Date.....3/22/83.....Permit No. 73-28**TOWN OF ACTON****APPLICATION FOR PERMIT TO CONSTRUCT WITHIN A PUBLIC WAY**

Re: Driveway Permit #83-28

SUBJECT: Notice of Inspection - Permit to Construct Within a Public Way # 83-28

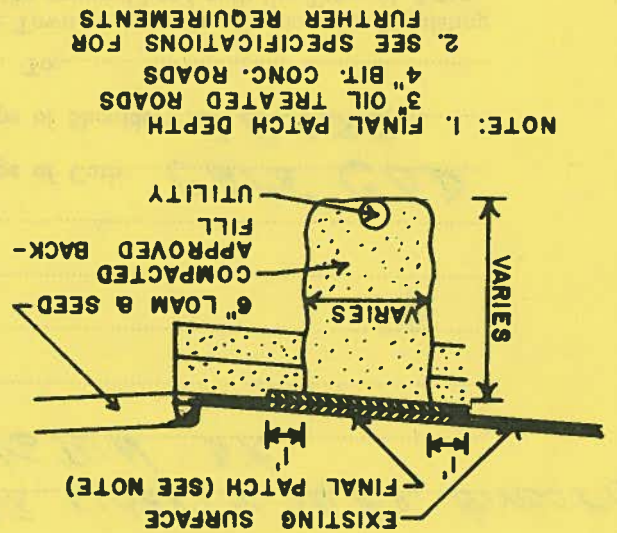
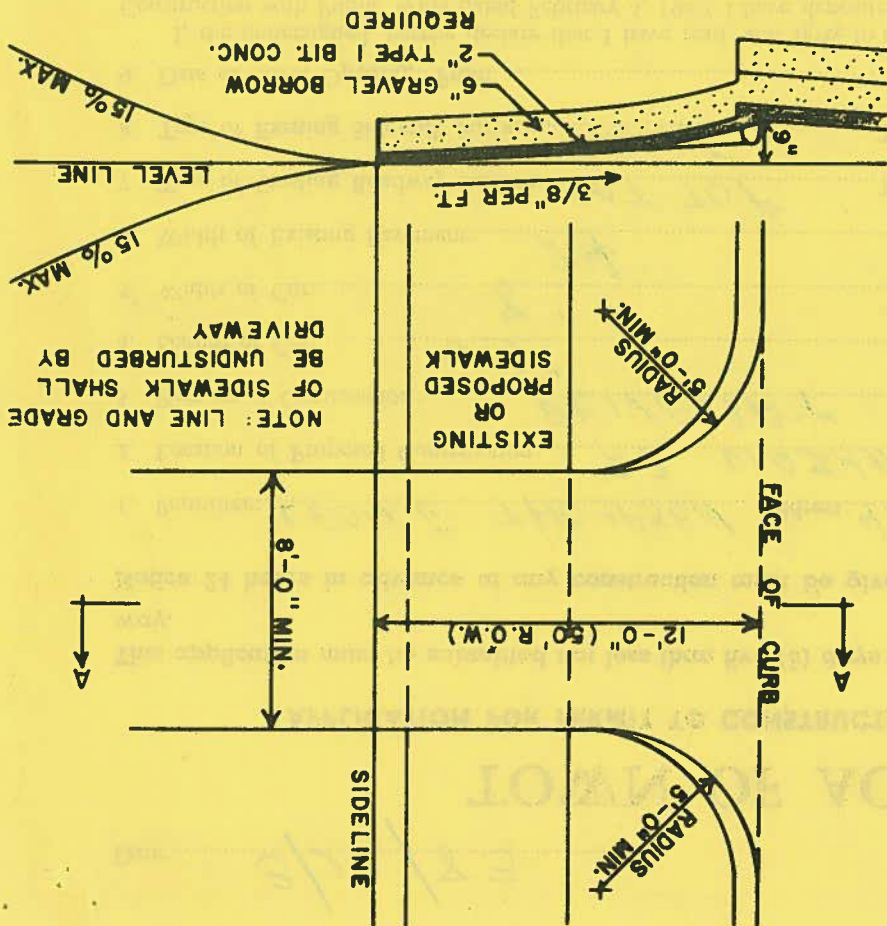
I have reviewed your driveway permit application for 22 Washington Drive and noticed that the proposed driveway grade is in excess of the Town recommended maximum of 15% (a 15 foot change of grade in 100 feet). By scaling from the proposed plot plan included with the building permit application it appears to be about 20%. This is a very steep grade for winter conditions.

Please consider revising your proposed plans in order to reduce the steepness of this driveway.
